DS-K1T331 Series MinMoe Terminal Release Notes (2022-02-09)

Device Model: DS-K1T331 DS-K1T331W	Firmware Version	ACS_331_AI2_EN_STD_V3.2.30_build211229 ACS_331_AI2_EN_NEU_V3.2.30_build211229
	SDK	Latest baseline
Naming Rule: W for WIFI	iVMS-4200 Client Version	Latest baseline

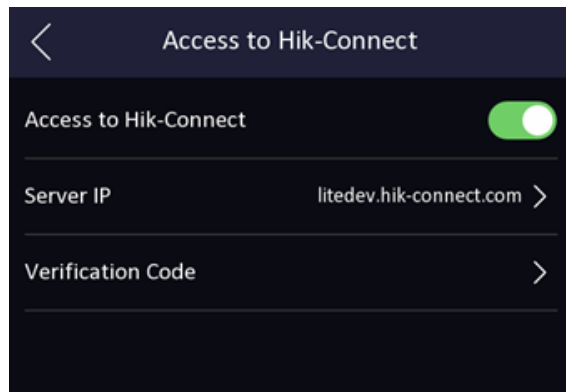
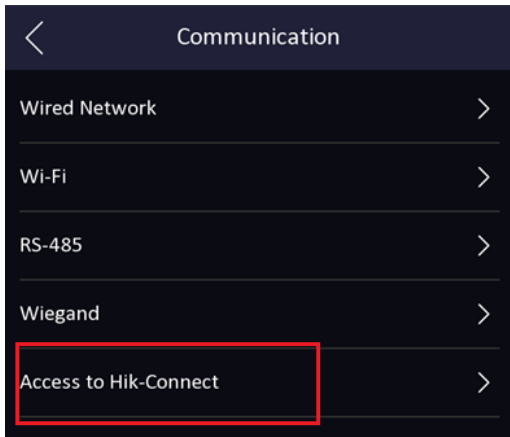
1. Fix the device offline issue caused by searching device event from iVMS4200 client through ISUP5.0 protocol;
2. Fixed some issues about ISAPI protocol.
3. Optimize the connection with HikCentral Professional platform;

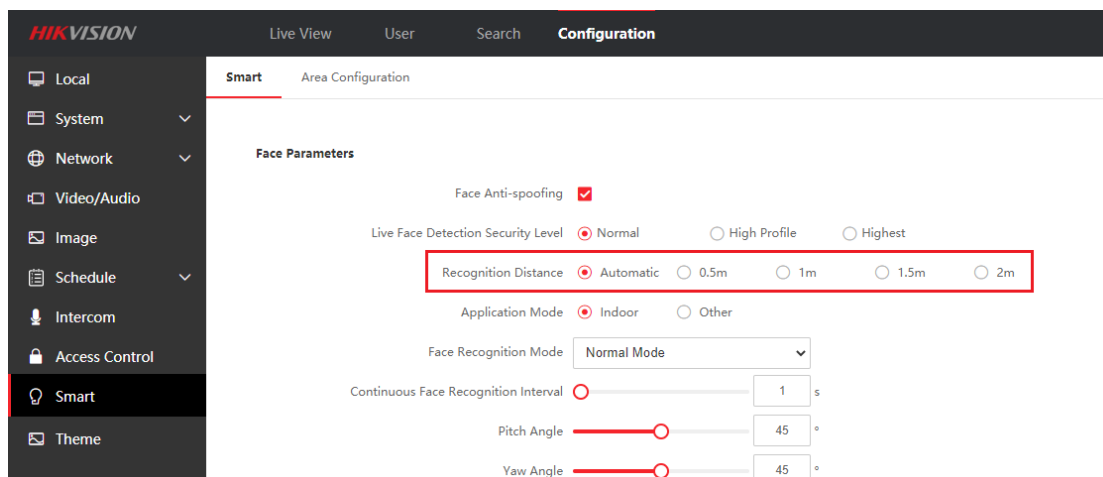
1. Add Hik-Connect menu in device UI Menu → Comm. The function is disabled in default.

1. Optimize the wake-up distance of the device screen through the face, and the wake-up distance is consistent with the recognition distance
